JORDAN VALLEY WATER CONSERVANCY DISTRICT
2025 Multi-Site Landscaping Project
March 17, 2025

ADDENDUM NO. 1

DATE	3/17/25
PROJECT NUMBER	4378
DRAWING NUMBER	L-1A
SHEET NUMBER	3 OF 15

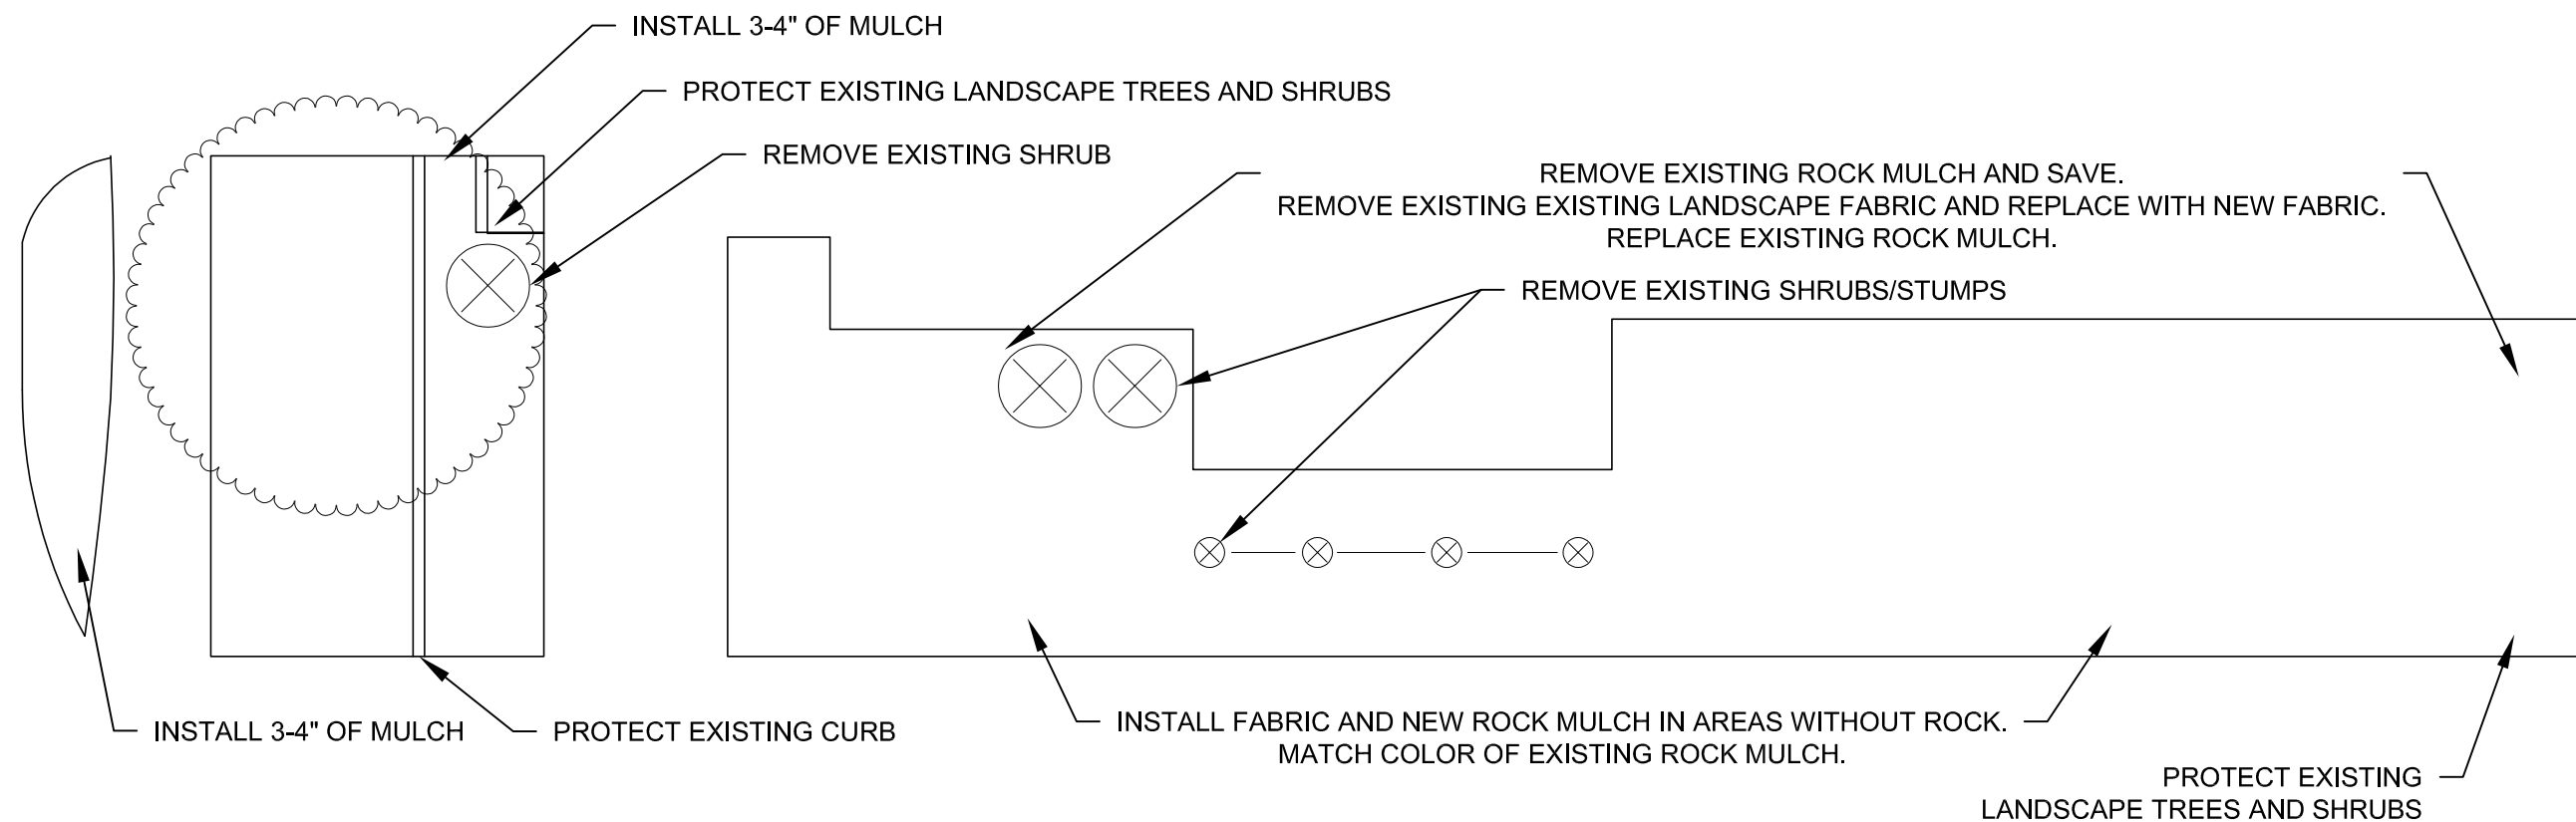
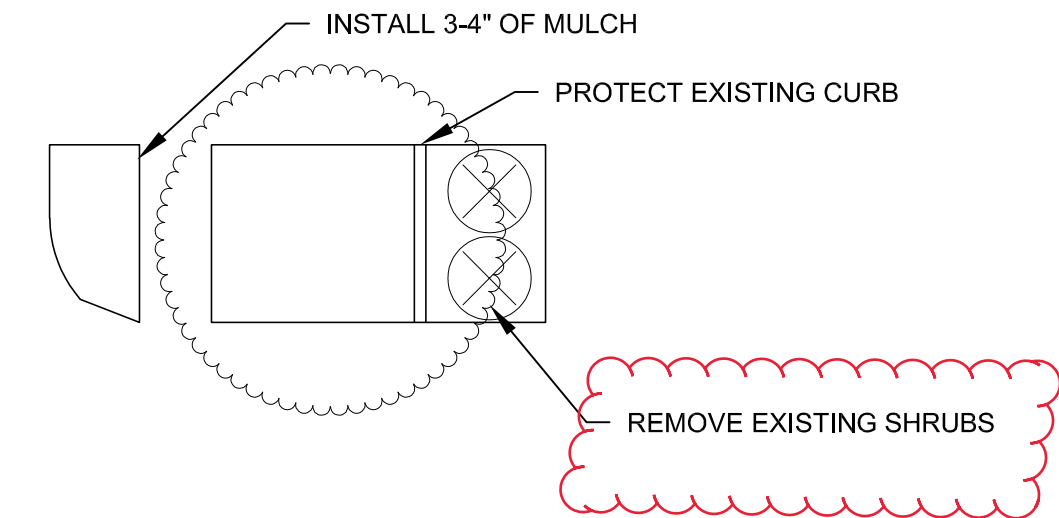
Item	Location	Description of Change
1.	Drawings L-1A	Call out changed from "Remove Existing Shrub" to "Remove Existing Shrubs" in upper left of drawing.
